**Ordinary Council meeting
Separate Attachments 1**

11.2	Private Plan Change 35 Tauriko Business Estate Stage 4 - Adoption and Notification of Decisions	
Attachment 1	IHC Recommendation Report - Appendix 1 - Recommended Changes to PPC 35 - 22 August FINAL.....	4
Attachment 2	IHC Recommendation Report - Appendix 2 - Recommendations on Submissions - 22 August FINAL	41
Attachment 3	IHC Recommendation Report - 22 August 2024 FINAL	48

Appendix 1: Recommended Amendments to Private Plan Change 35 to the Tauranga City Plan, Tauriko Business Estate Stage 4

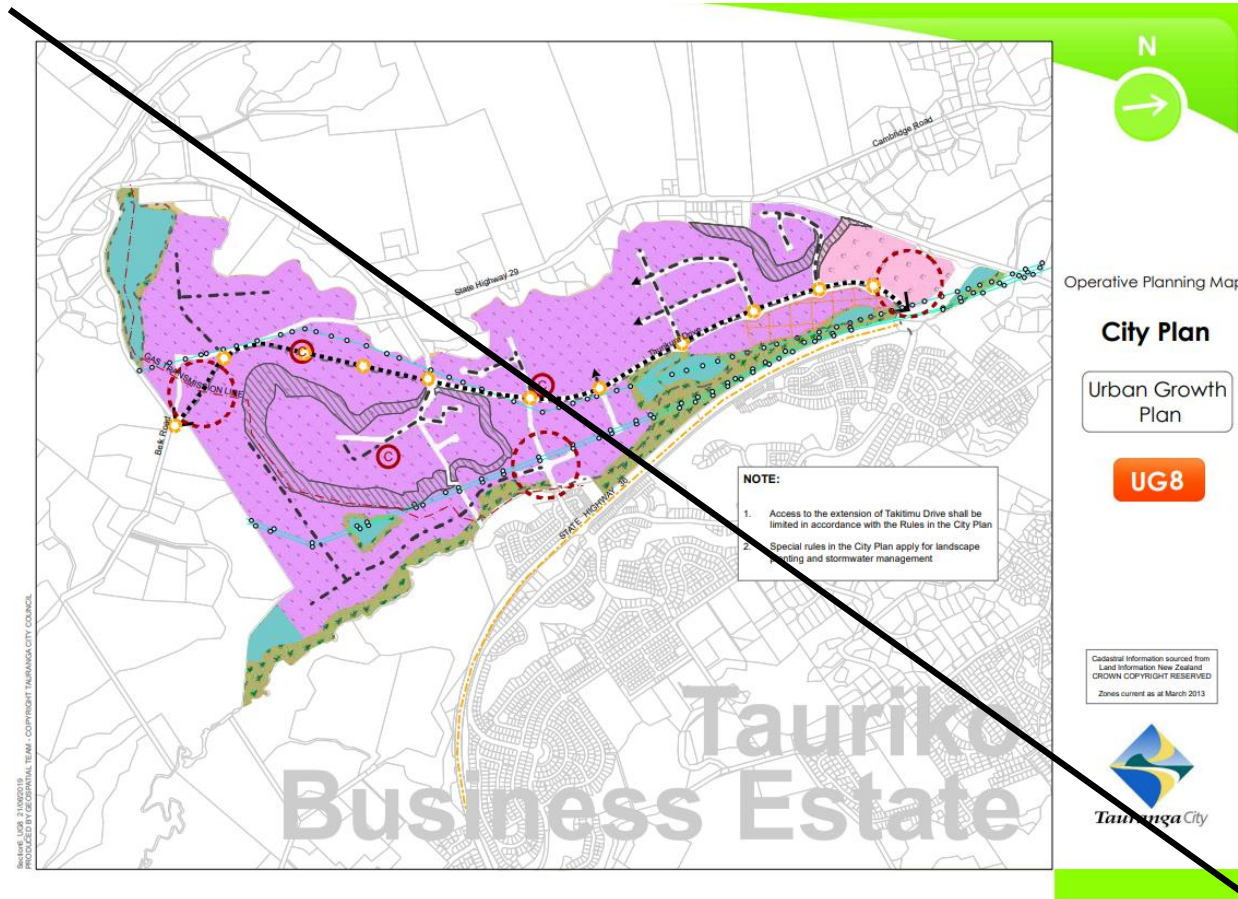
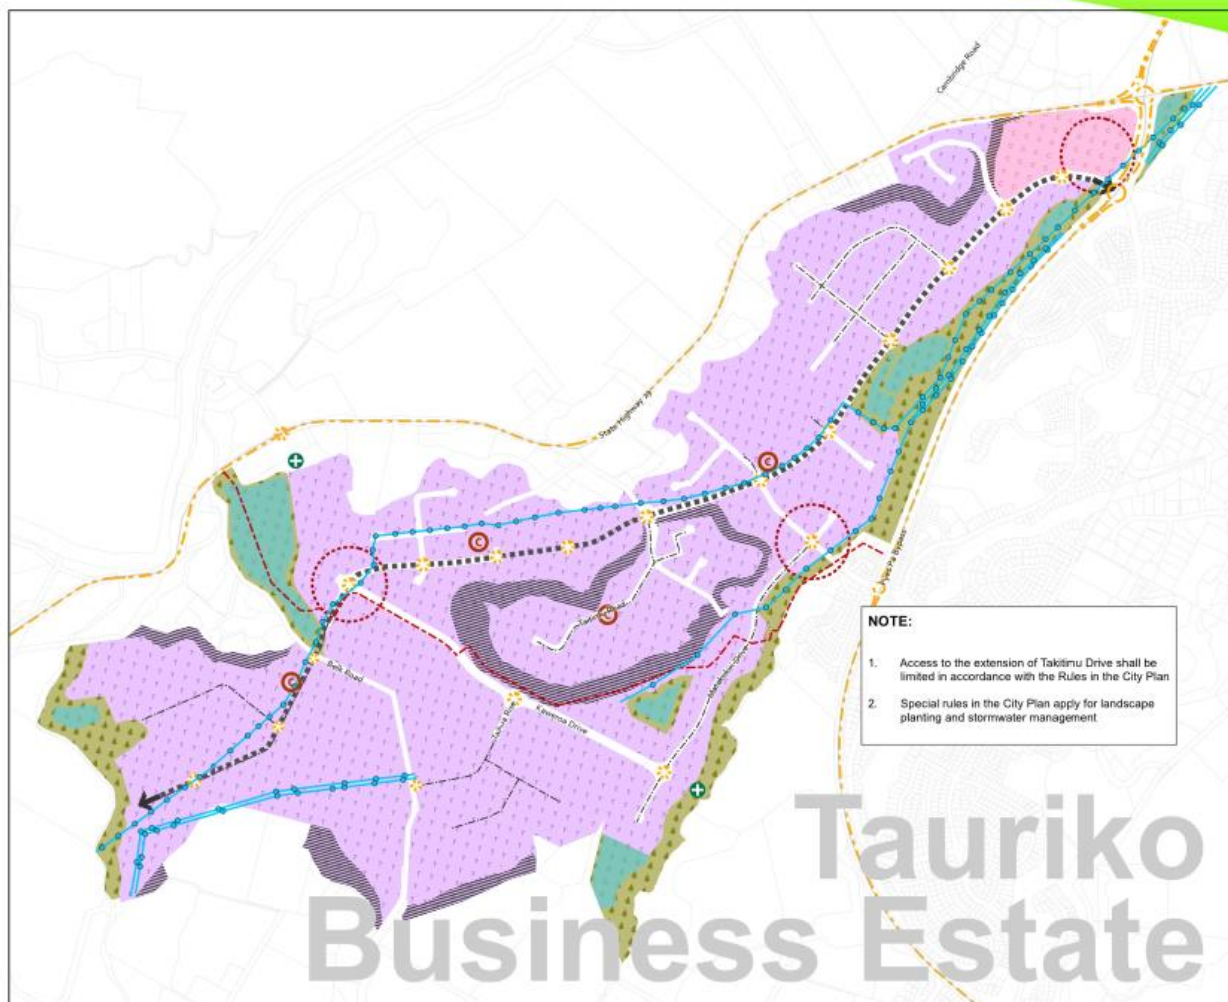
Amend Section 6: Urban Growth Plans, UG8 by replacing UG8 as follows (New Image below)
